**RESOLUTION HOLDING HEARING ON REQUEST FROM JJ EQUITY, LLC TO REZONE
PROPERTY LOCATED AT 3300 EAST 56TH STREET FROM "A-1" AGRICULTURAL DISTRICT TO
"PUD" PLANNED UNIT DEVELOPMENT DISTRICT**

RE: Brook Landing PUD Rezoning

BROOK LANDING
PUD CONCEPTUAL PLAN

STAFF REPORT TO THE PLANNING COMMISSION

DESIGN: J. L. HANSEN, P.E., CIVIL ENGINEER
DATE: 10/15/2015
PROJECT: BROOK LANDING PUD
SHEET: 2 OF 3

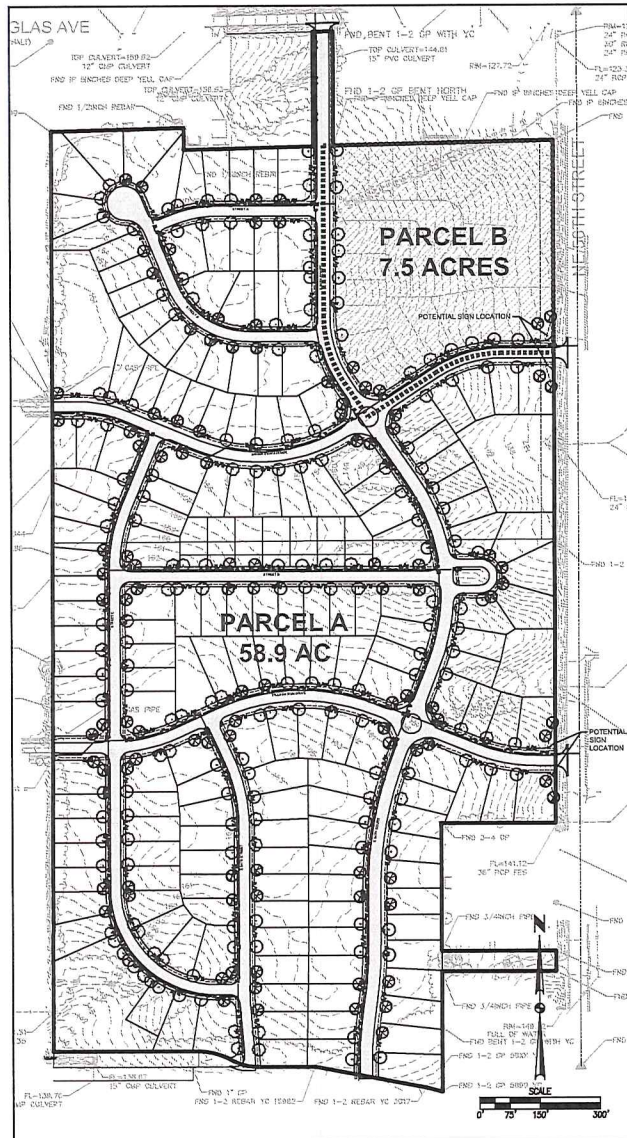
Condition 17: Side yard setbacks

We are requesting 5' side yard setbacks instead of R1-60 7' minimum/15' total.

- The single family lots immediately to the west in Brook Run are 50' – 57' wide with 5' side setbacks and 20' front setbacks. Brook Landing lots are a minimum of 60' wide with a front setback of 30' for the house and garage, 25' for a porch.
- The reduced setback allows for flexibility and the most efficient use of the lot, as the side yards are nonfunctional areas, and most floor plans minimize, if not eliminate, windows on the sides.
- The reduced setback will allow a 3 car garage option and larger, nicer homes resulting in a greater overall tax base in the area.

SIDE SETBACK: 5' MINIMUM

PHASING PLAN

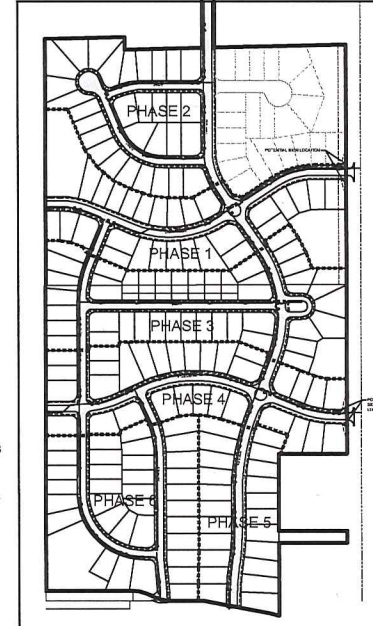
Condition 18: 70' wide lots in phases 5 & 6

Staff has requested this to act as a transition to the approved, but not constructed Copper Crossing PUD to the south.

- We understand the desire for transition, but this requirement is excessive. It is asking that 56 lots provide a transition for 51 lots that themselves are adjacent to duplex lots and an apartment lot. See the attached sketch.
- With the reconfiguration of Brook Landing streets (Item #6) we have provided 26 lots at 70' wide. This is certainly an adequate transition.

- #18 –Phase 5 and Phase 6 in 70 feet lots. They have been asked to connect to the road from Copper Crossing so the lots will change a little bit because of the layout of those streets. Their proposal is since they have the two streets connecting the first three or four lots north of Copper Crossing would be the 70 foot lots and after that they move down to the 60 foot lots.
